PLAN-009605

Proposal: Demolition of porch & conservatory & erection of single storey rear/side extension.

Site: 6 Elmcroft Place, Westergate, PO20 3XL.

Southern Water MapGuide Browser

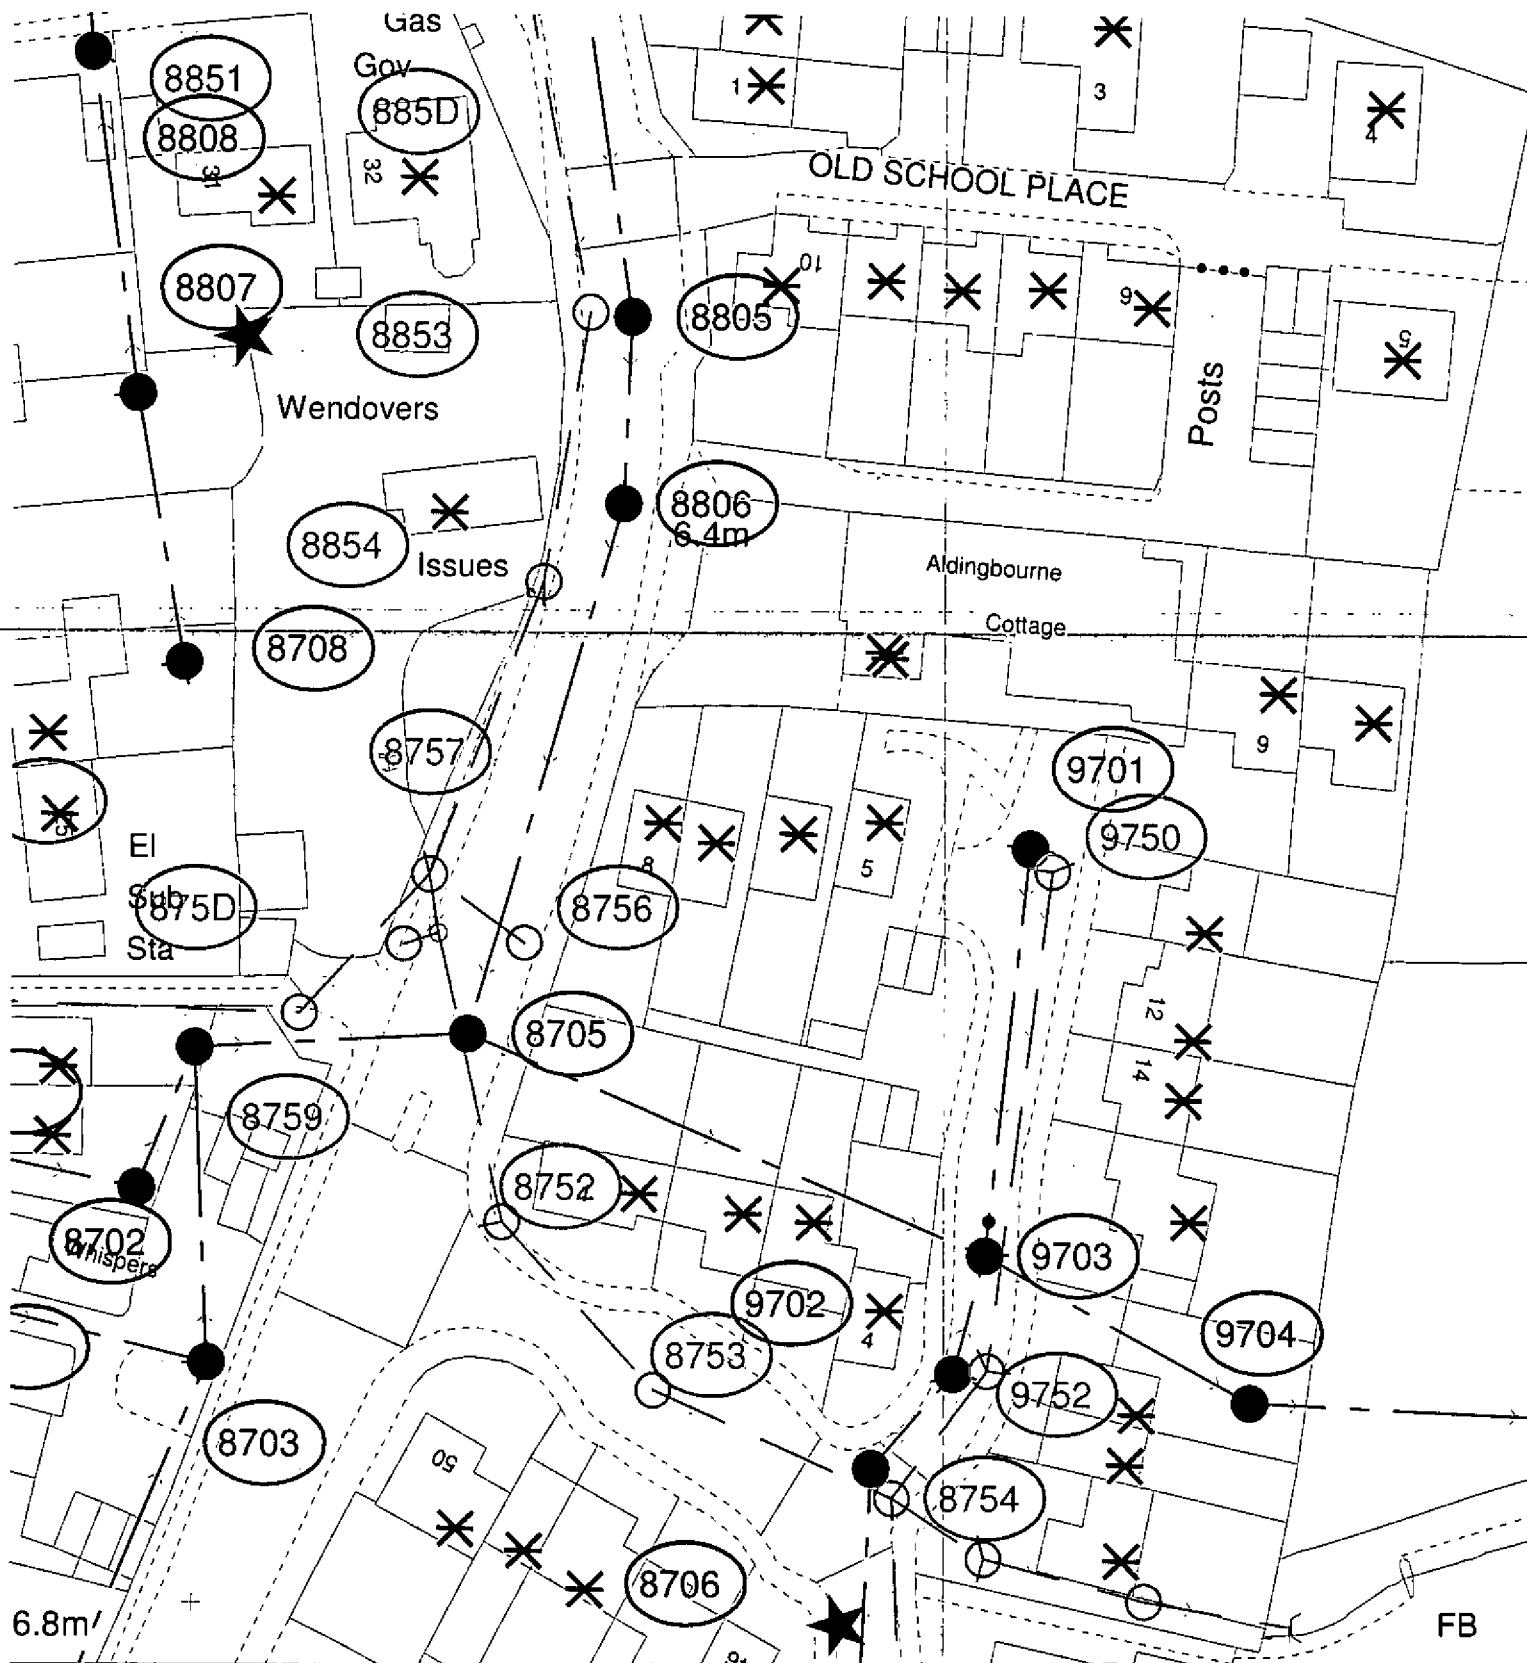
Due to changes in legislation that came in to force on 1st October 2011 regarding the future ownership of sewers it is possible that a sewer now deemed to be public could be crossing the above property. Therefore, should any sewer be found during construction works, an investigation of the sewer will be required to ascertain its condition, the number of properties served, and potential means of access before any further works commence on site.

The positions of pipes shown on this plan are believed to be correct, but Southern Water Services Ltd accept no responsibility in the event of inaccuracy. The actual positions should be determined on site.

WARNING: BAC pipes are constructed of Bonded Asbestos Cement

WARNING: Unknown (UNK) materials may include Bonded Asbestos Cement

The applicant is advised to discuss the matter further with Southern Water, Sparrowgrove House, Sparrowgrove, Otterbourne, Hampshire SO21 2SW (Tel: 0330 303 0119) or www.southernwater.co.uk.
